Co3072 – Jericho BF 0209(10)

ADDENDUM #1

REVISED: Plan Sheets 2, 5, 7, 23, 24, and 40 and Invitation for Bids.

QUANTITY SHEET 2

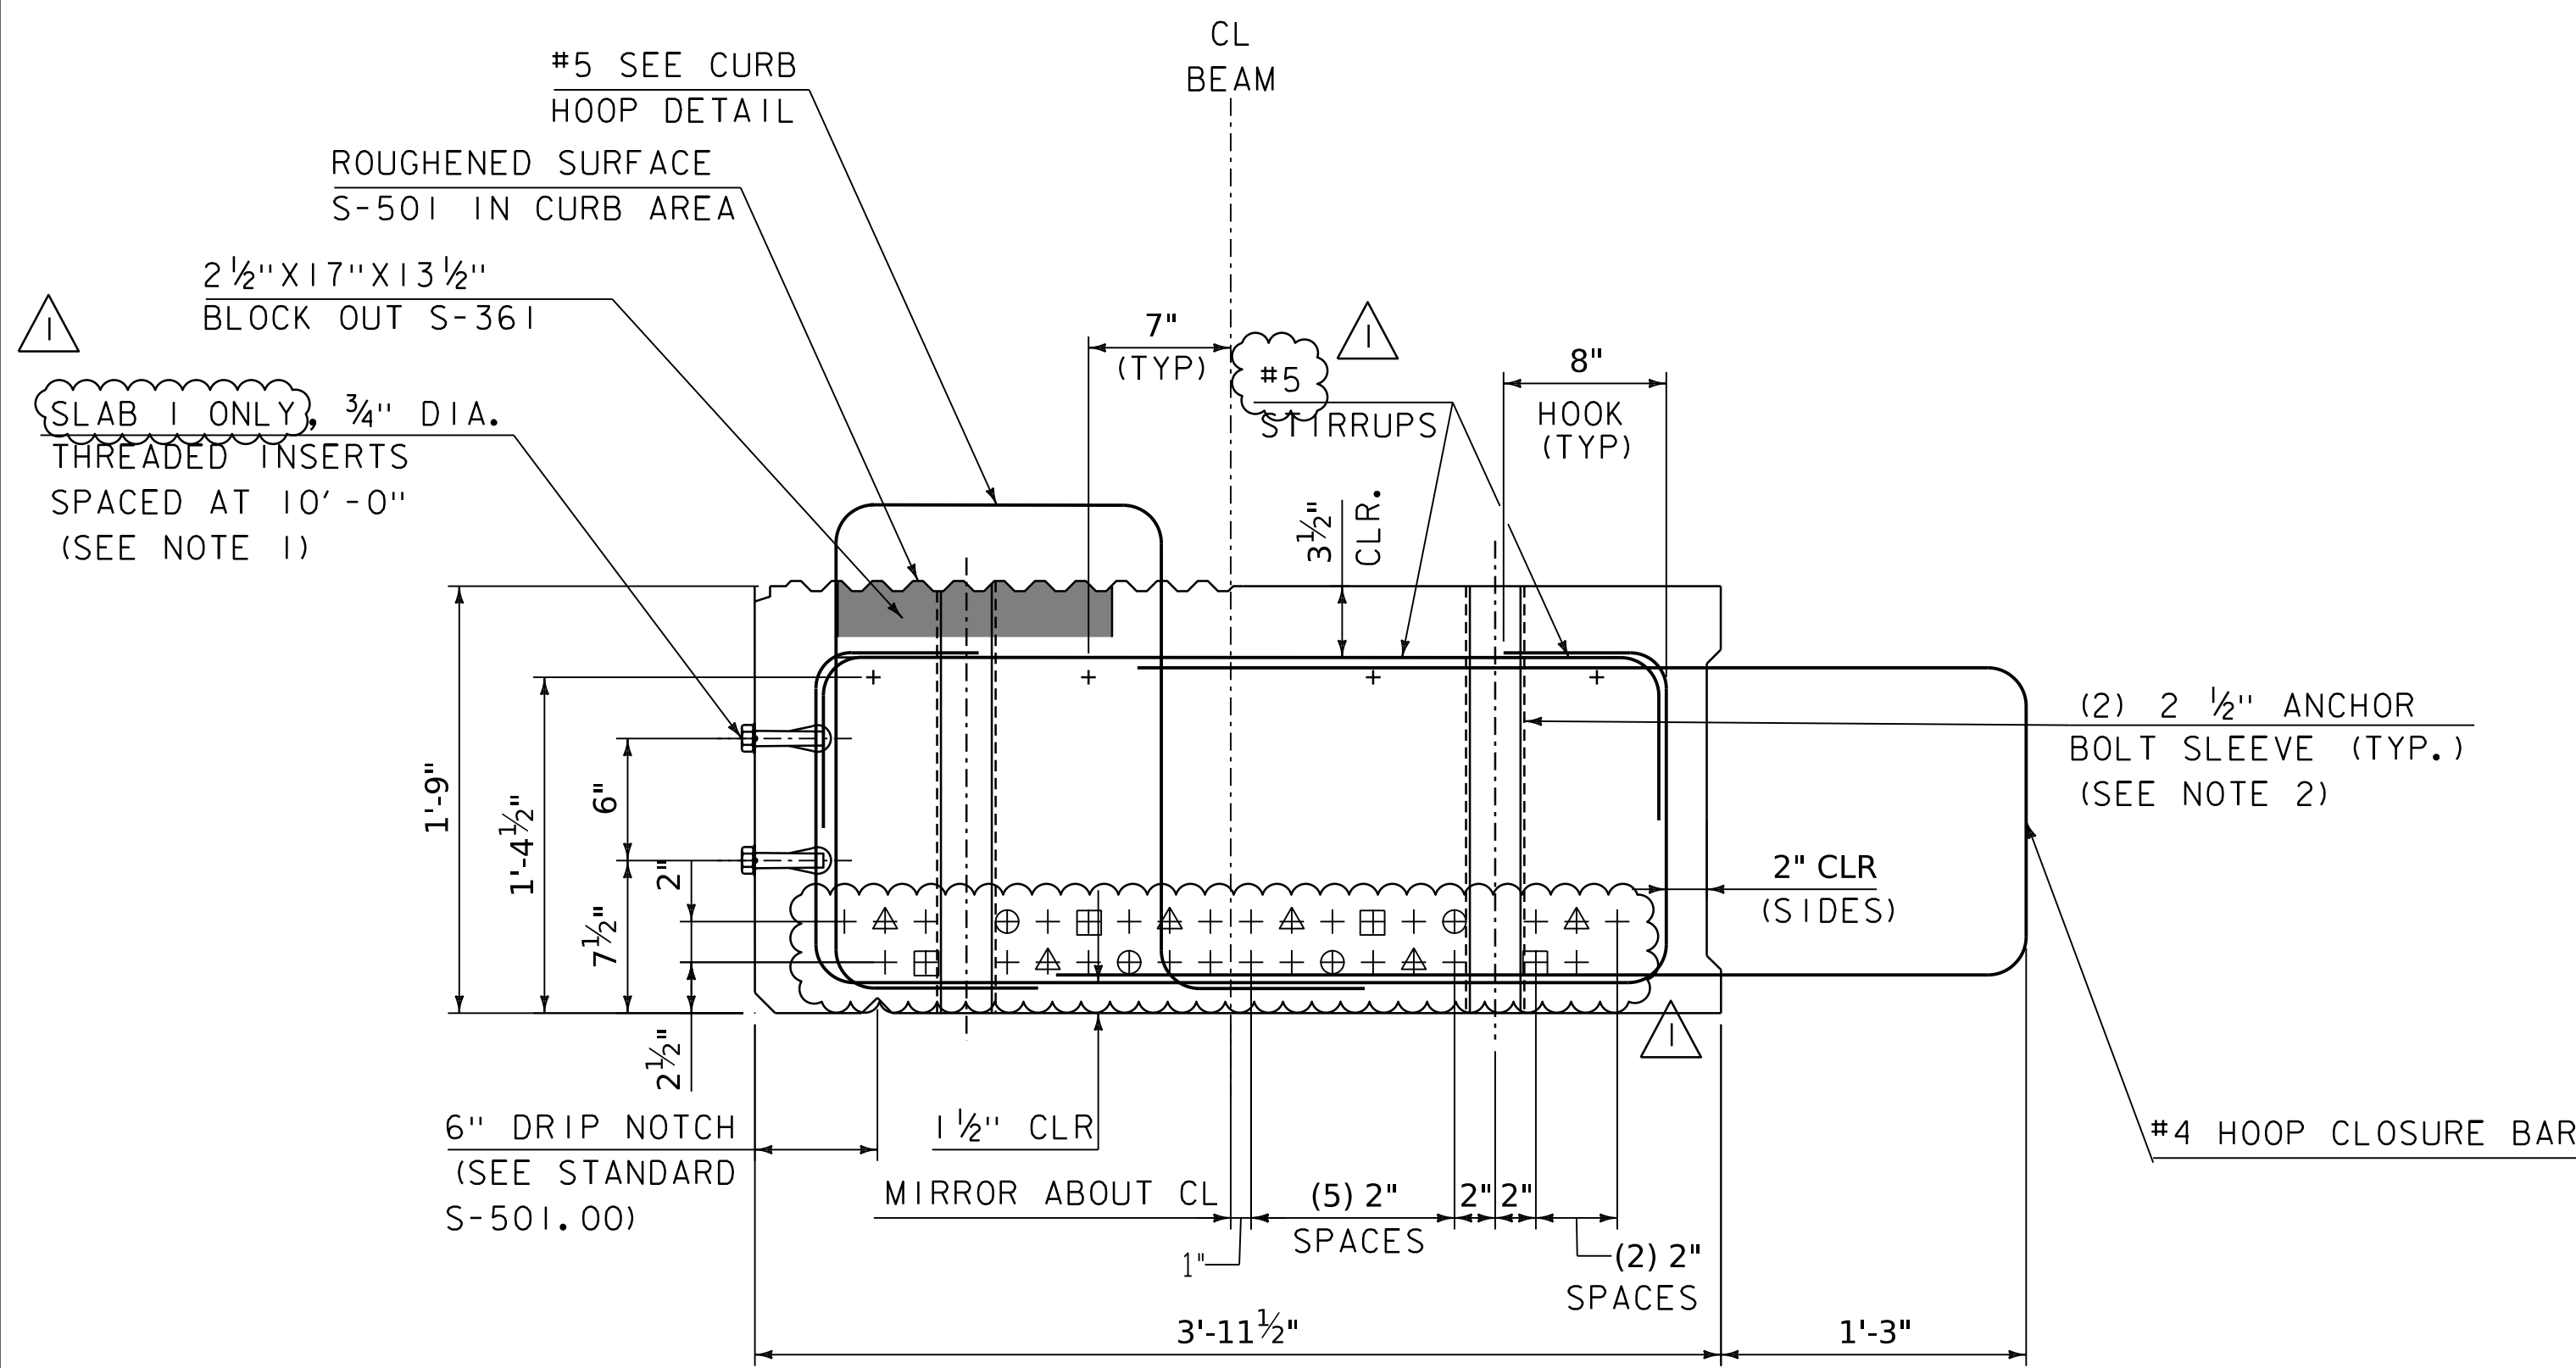
ADDENDUM	REVISION	DATE	BY	DESCRIPTION
△	I	11/05/2024	VAOT	ITEM CHANGED

PROJECT NAME:	JERICHO
PROJECT NUMBER:	BF 0209(10)
FILE NAME:	sl2j634sup.dgn
PROJECT LEADER:	R. YOUNG
DESIGNED BY:	A. MANN
SOLID SLAB & CLOSURE POUR DETAILS	
PLOT DATE:	5-NOV-2024
DRAWN BY:	R. PELLETT
CHECKED BY:	F. BARROWS
SHEET	23 OF 51

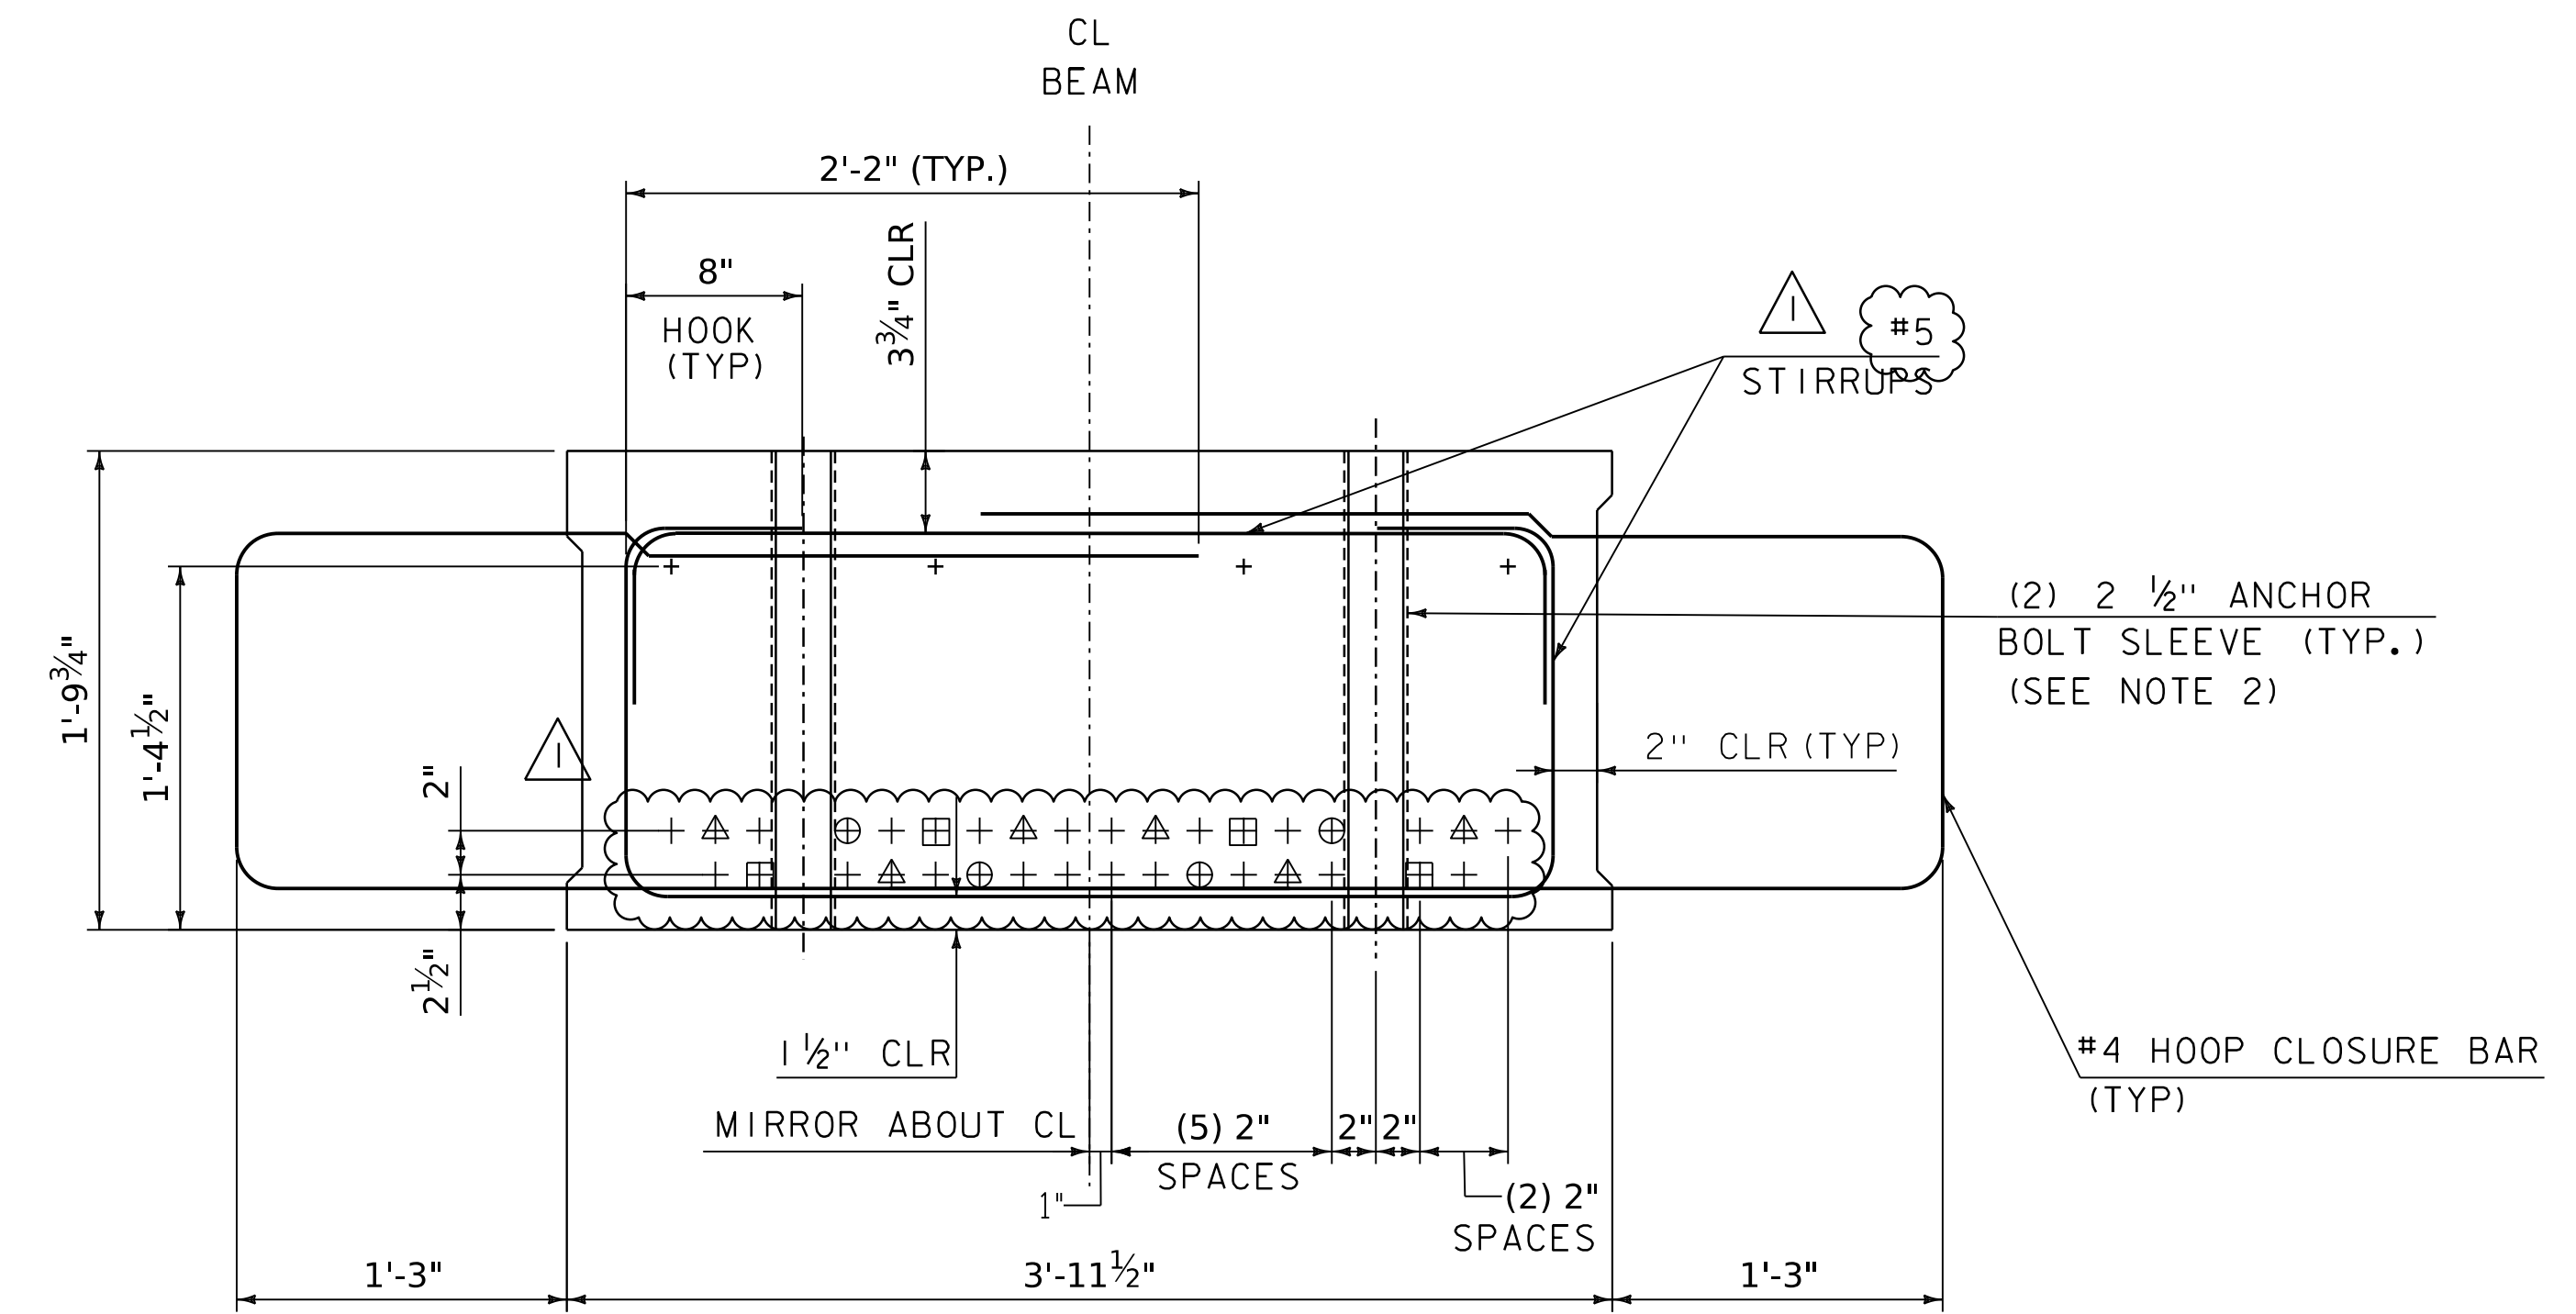
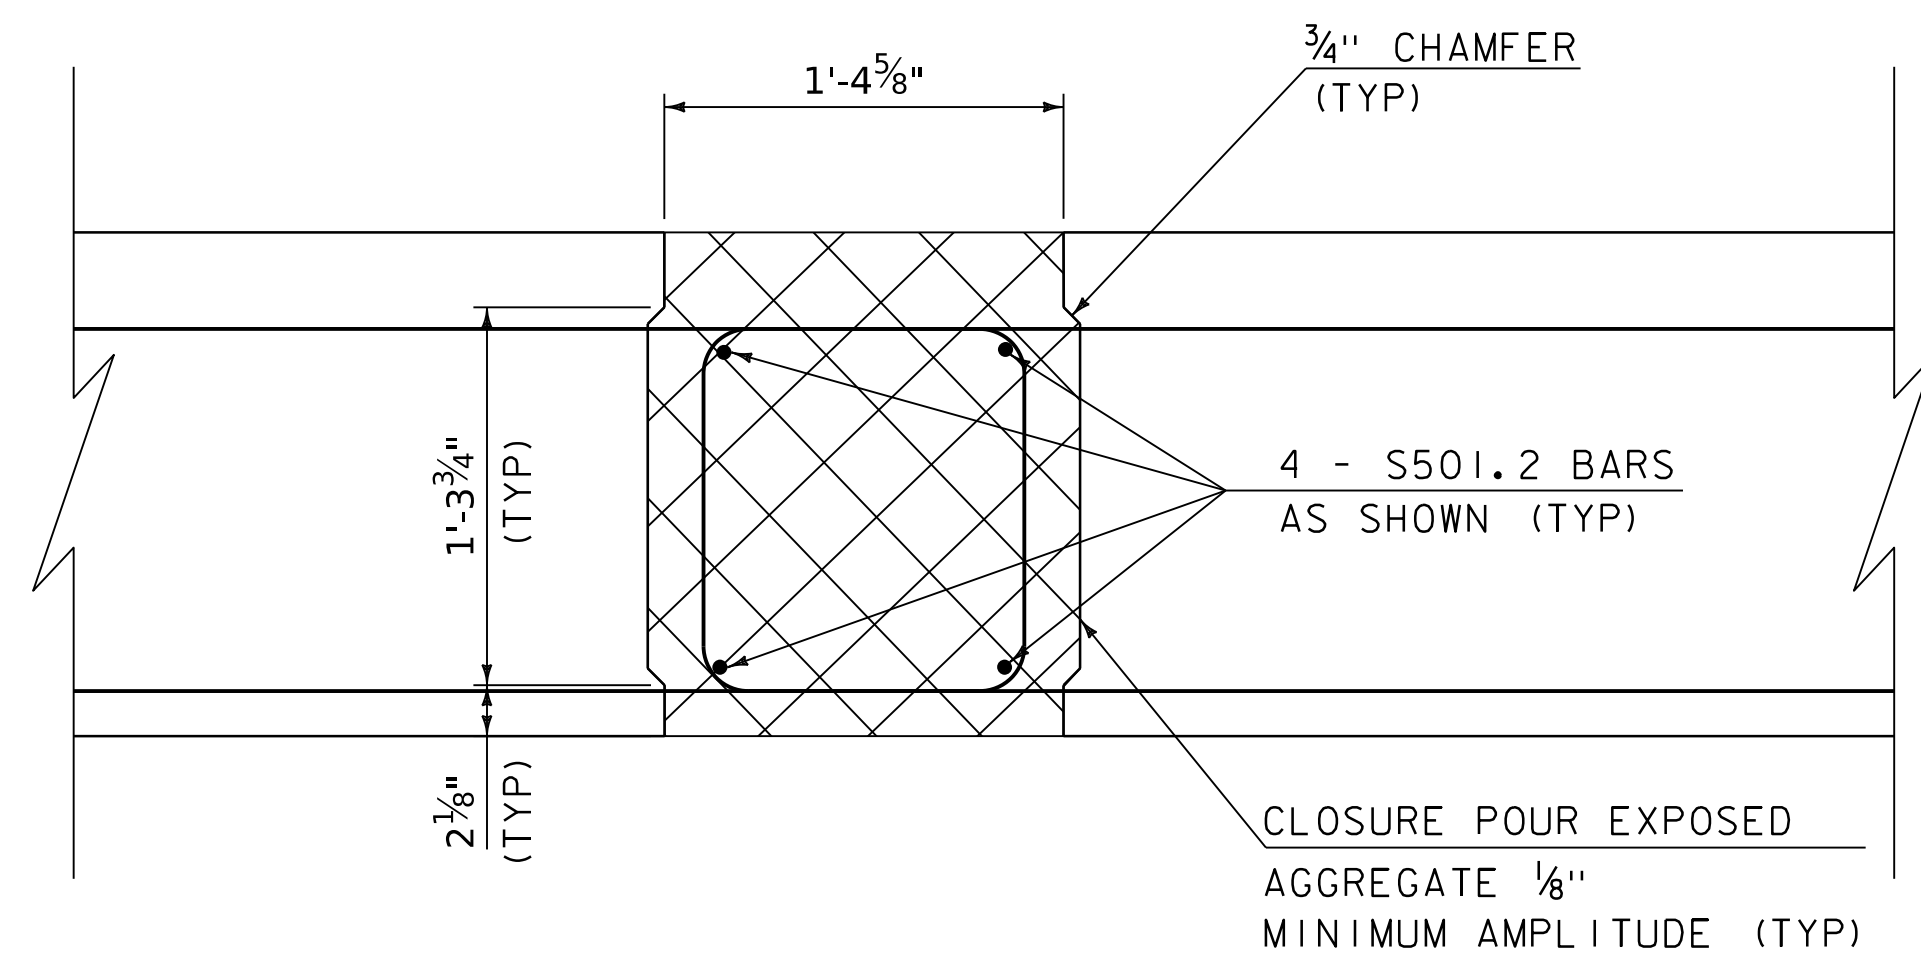
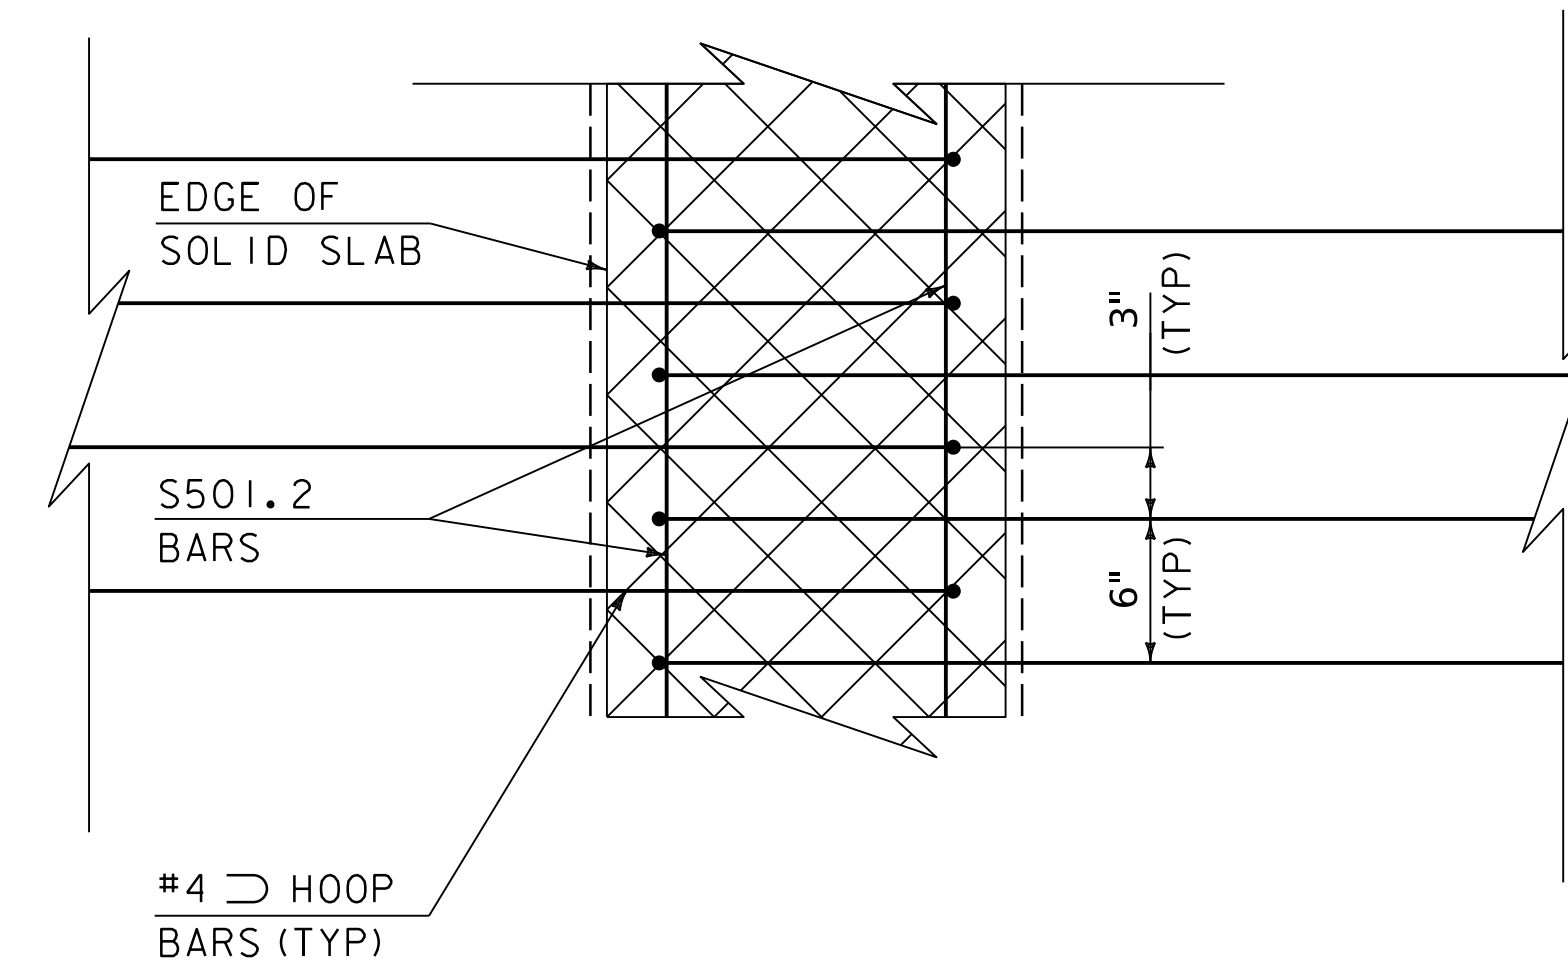
ADDENDUM	REVISION	DATE	BY	DESCRIPTION
1	I	11/05/2024	VAOT	STIRRUP SIZE DEBONDING, AND INSERTS

- NOTES:**
1. NC THREADED INSERTS, FOR 3/4" DIAMETER BOLT, HOT DIP GALVANIZED INSERTS, USE MEADOW BURKE FX-51 OR APPROVED EQUIVALENT.
 2. SLEEVES SHALL BE REMOVED FROM SLABS PRIOR TO GROUTING ANCHOR BOLTS.
